GIS Drain Input Checklist

RE: John Beaver Drain

Re: John Beaver Drain
Mansur Relocation

AS-BUILT PLAN
JOHN BEAVER REGULATED DRAIN
HAMILTON PROPER
FISHERS, INDIANA

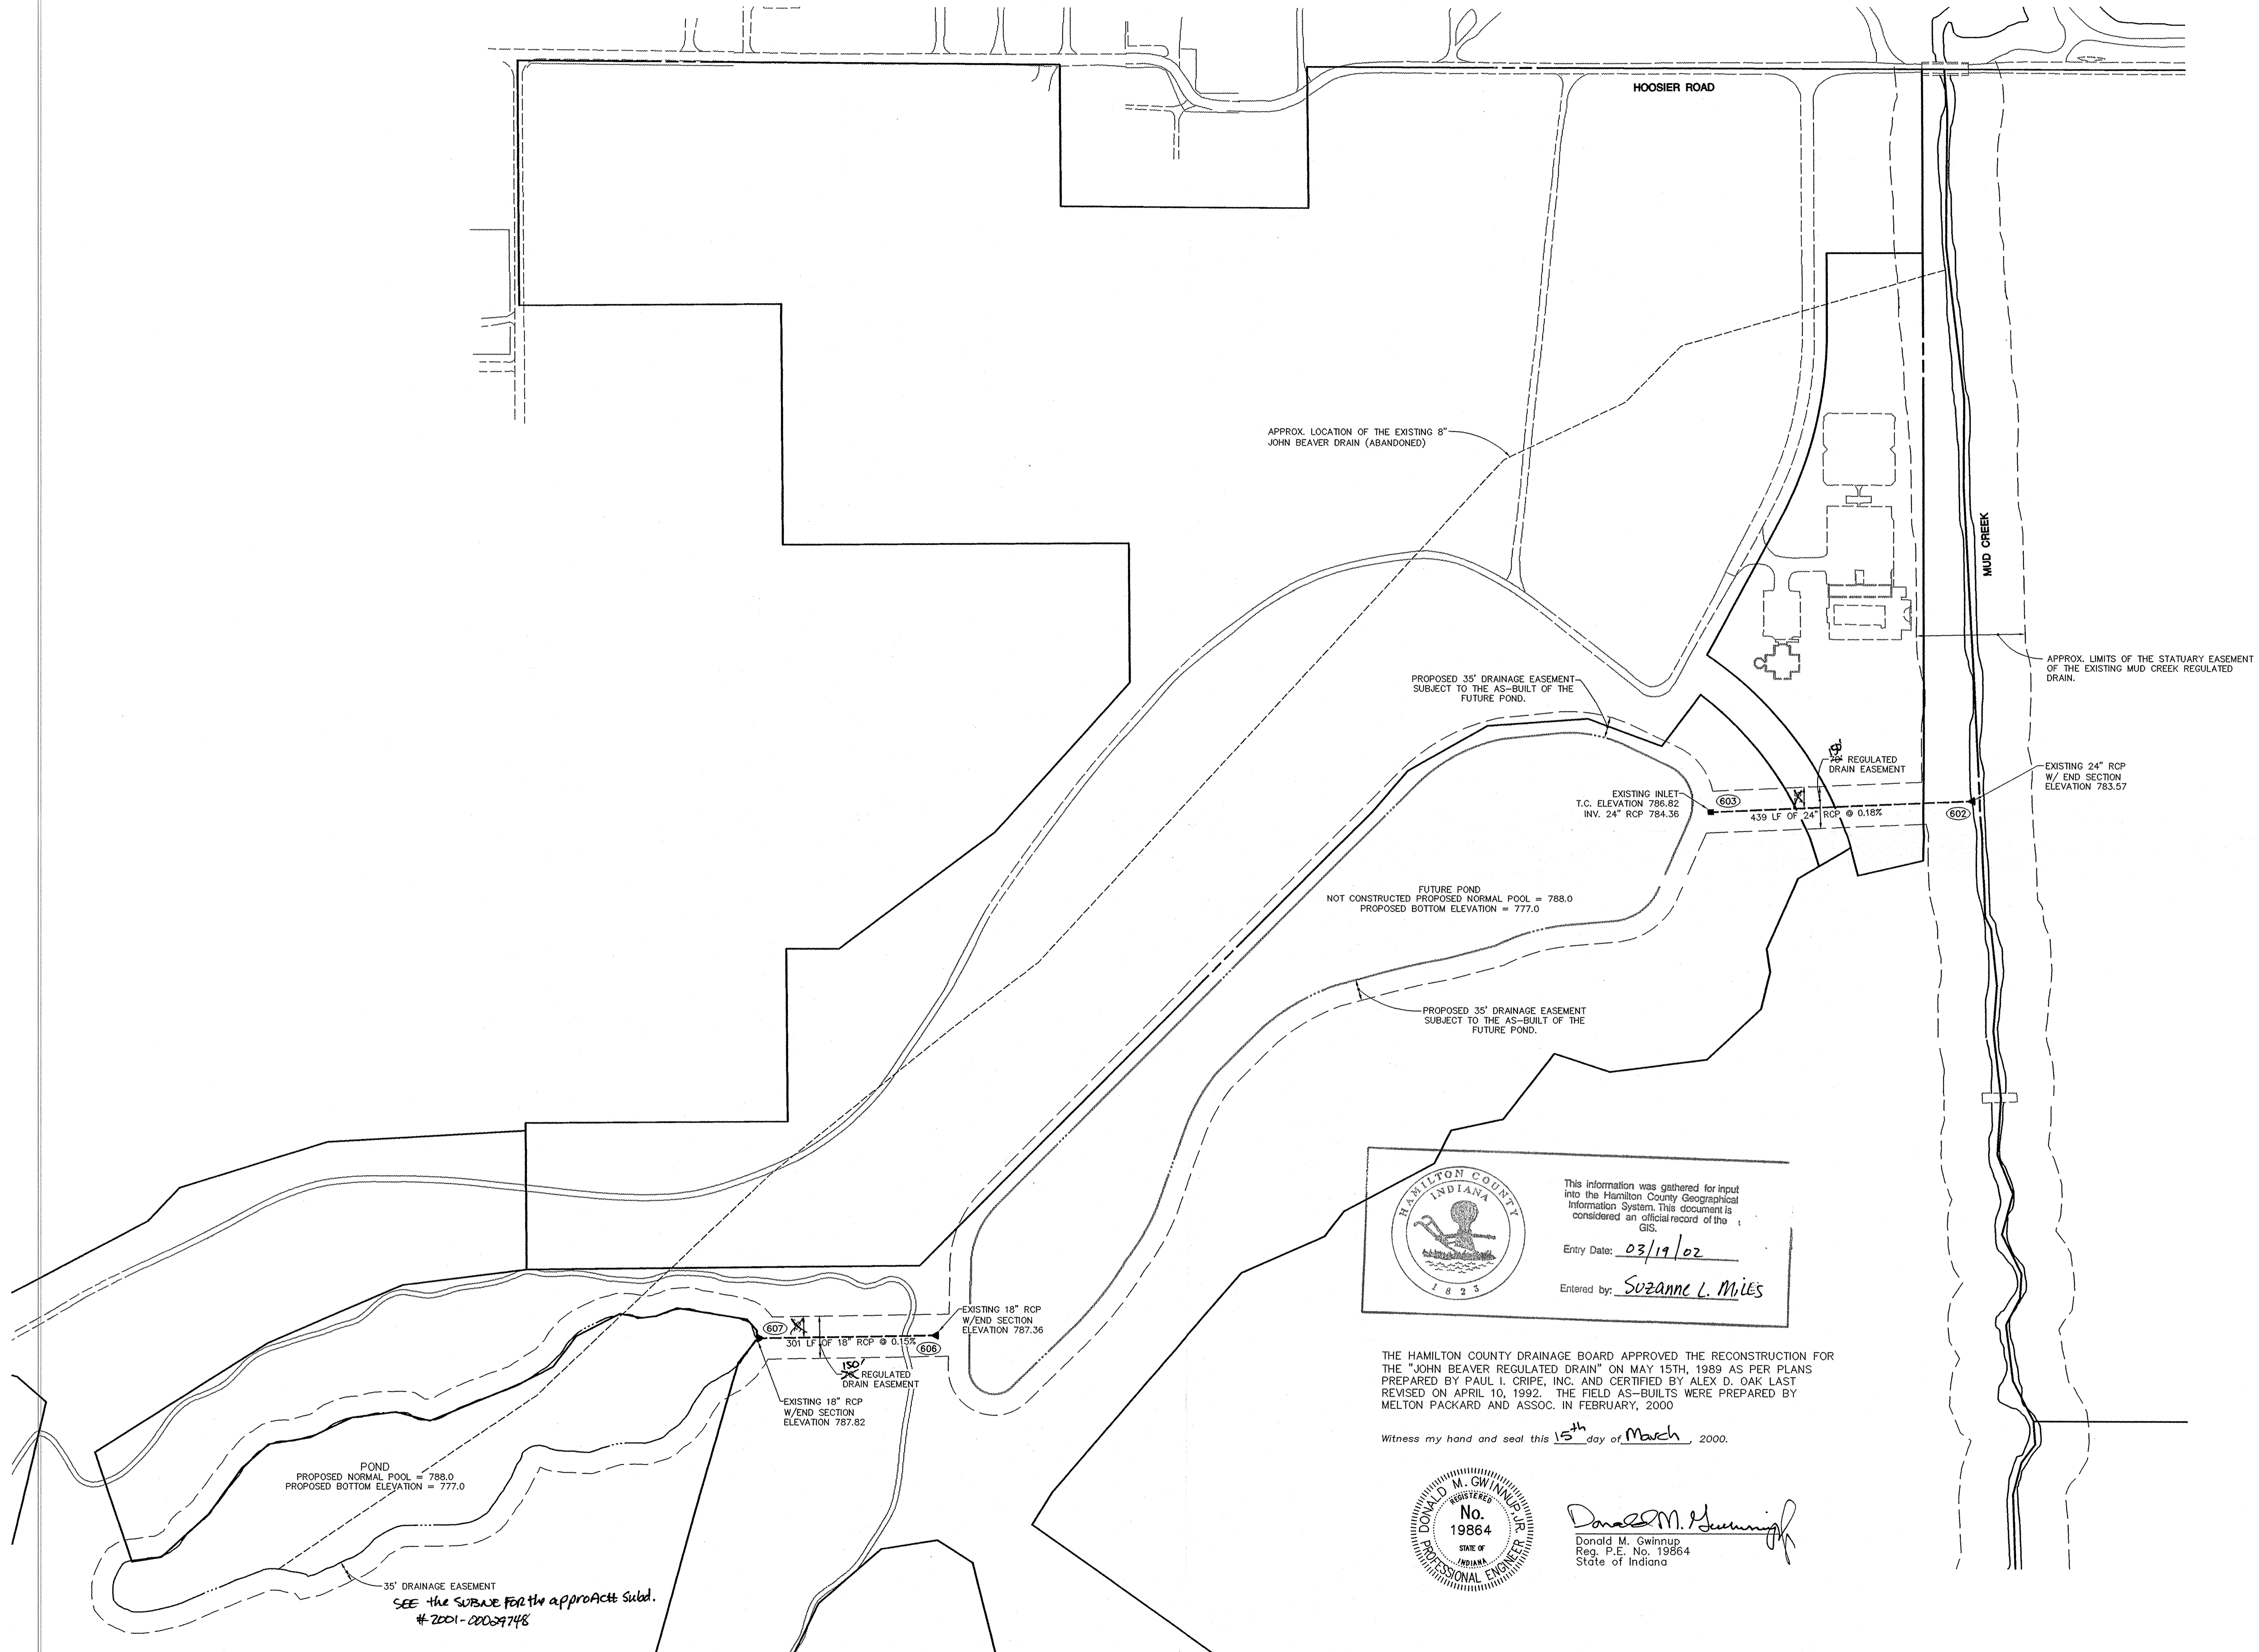
During construction, changes were made to the drain, which will alter the plans submitted with my report for this drain-dated February 21, 1989 and April 16, 1992. The approval of these reports can be found in DR Book 2 pages 363-364 and DR Book 3 page 16. The changes are as follows: Structure 607 – 606 consists of 301 feet of 18” RCP this was shortened from 305 feet (See Original Plans -Sheet C702 Plan 1). Structure 603 –602 consists of 439 of 24” RCP this was shortened from 445 feet (See Original Plans – Sheet C701 Plan 2). The length of the drain due to the changes described above is now 740 feet. The original John Beaver Drain was vacated from Sta 0 to Sta 36+00. Therefore the drain has a total length of **740 feet**.
